Title: DISPLAY.EPC

Size A	Document Number	Rev B
Date: Fri, January 16, 2004

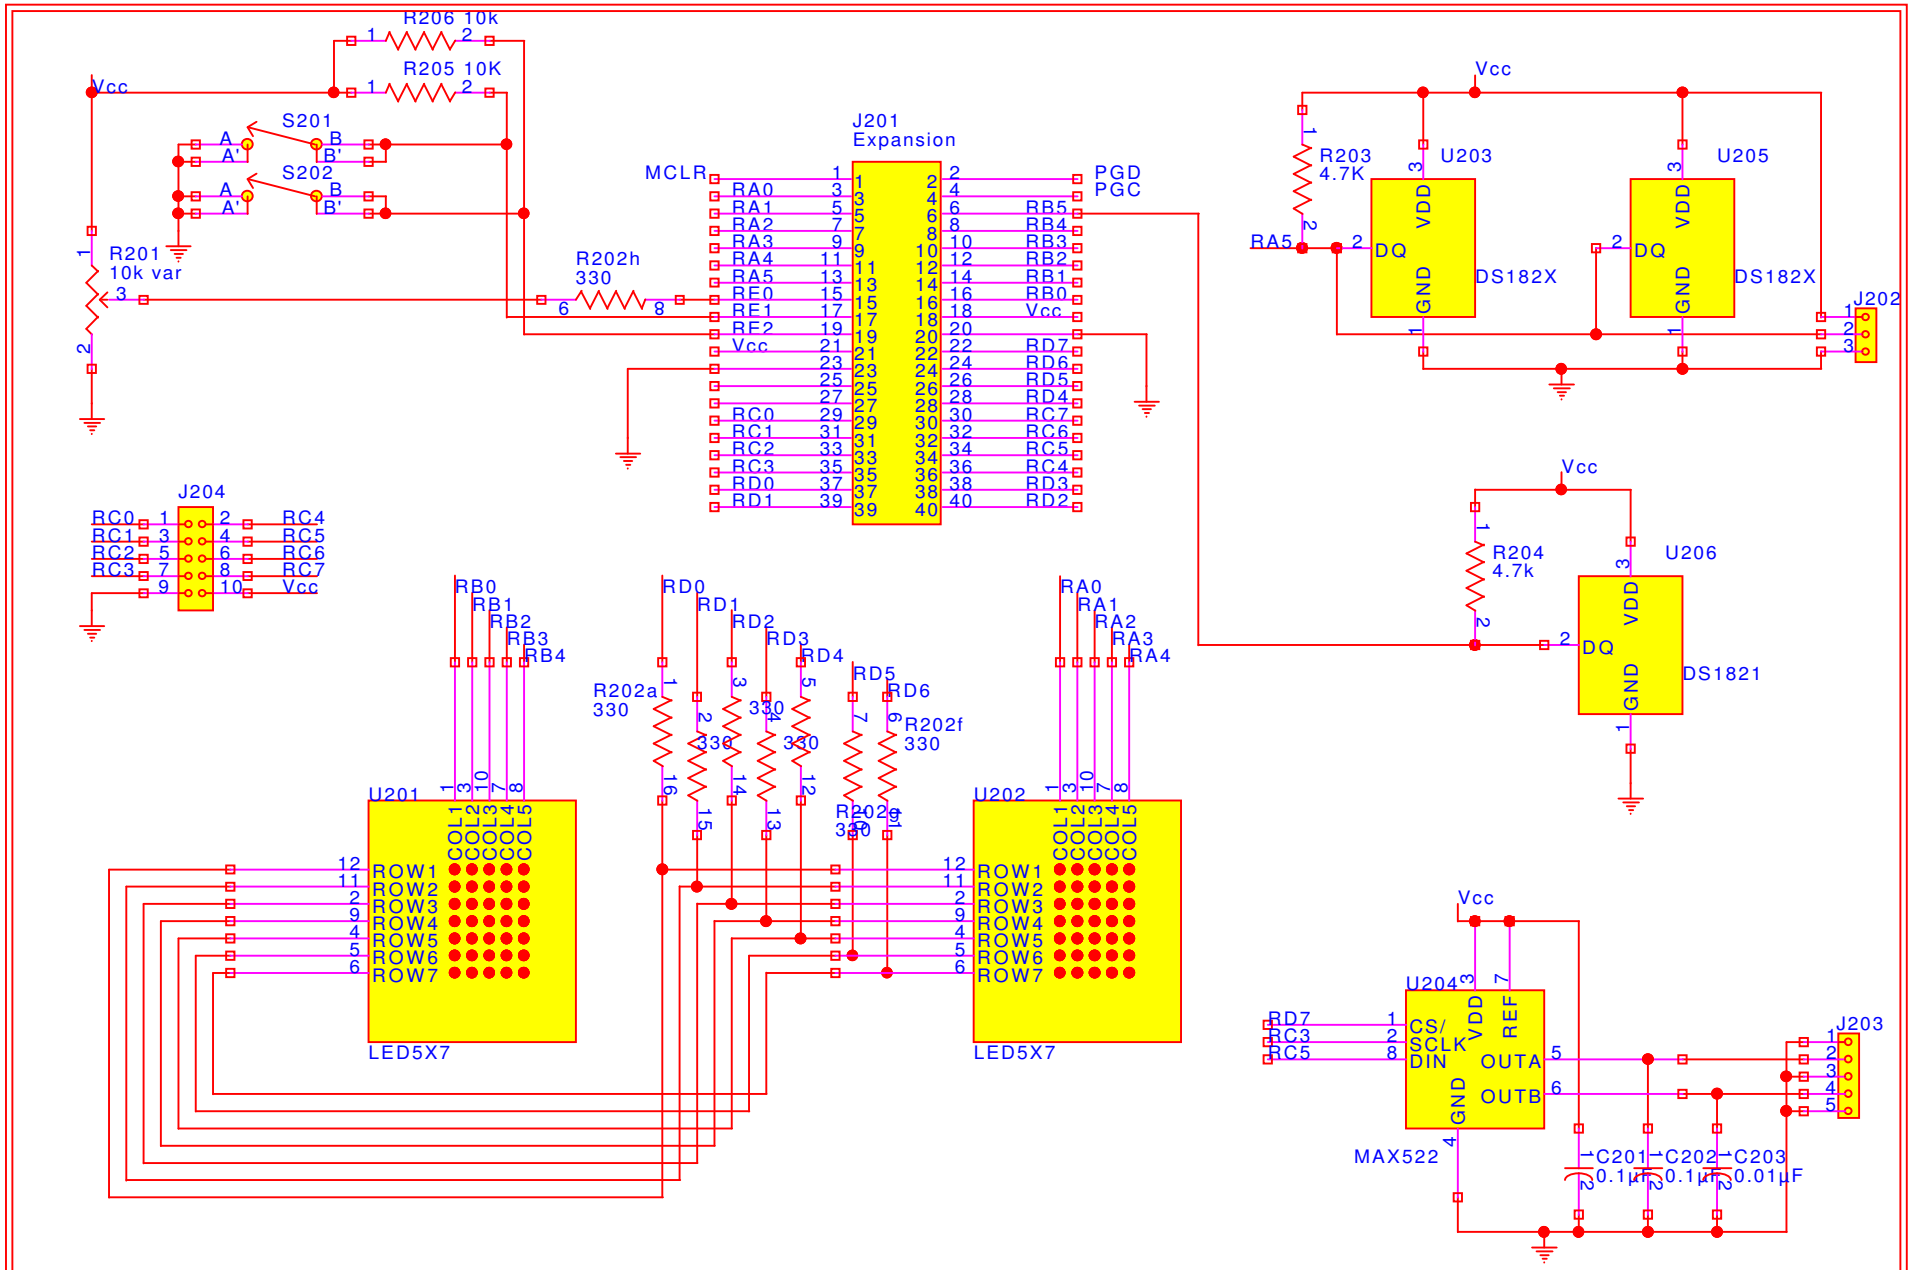
Date	Rev	Changes
2003/08/11	B	Seperated column control lines for U201 and U202 resulting in changes to J204 switch connections, and 1-wire bus
